Urgent Field Safety Notice

Commercial name of the affected product: ARIETTA 60 & 70 series

FSCA-identifier: FE0618/14

Type of action: Device modification

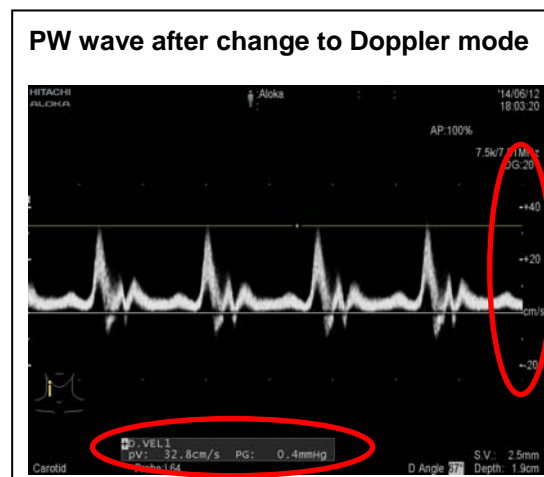
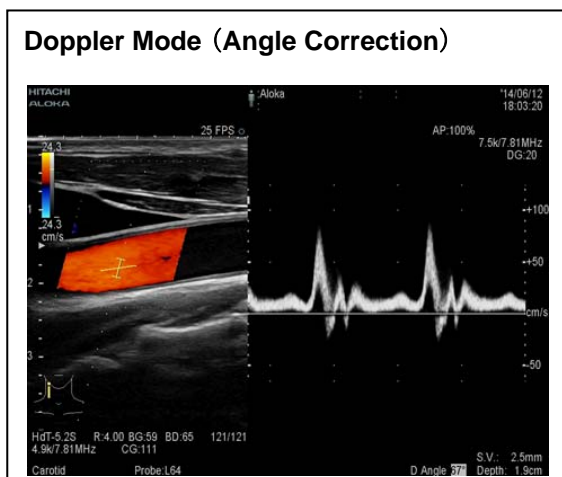
- Phenomenon : Doppler scale of Full Doppler display mode, PW or CW, becomes an incorrect value.
- Condition : The phenomenon occurs when measured only on full Doppler display mode, PW or CW.
- Procedure :
 1. When Angle Correction value is set other than 0° on Doppler mode.
 2. When a mode is changed to Full Doppler display mode only.
- Frequent : 100% occurs by above procedure.

However, freeze or angle correction adjustment on wrong Doppler scale display makes correct value displayed. There is no problem on 2 displays like B and Doppler mode as a following left side image.

Freeze or angle correction adjustment on wrong Doppler scale display makes correct value displayed. Do not use the wrong display images stored into RGB or Video Clip.

Hitachi Aloka will provide corrective software for all applicable units. A Technical Bulletin will be issued by the manufacturer for this case by the 7th of July 2014.
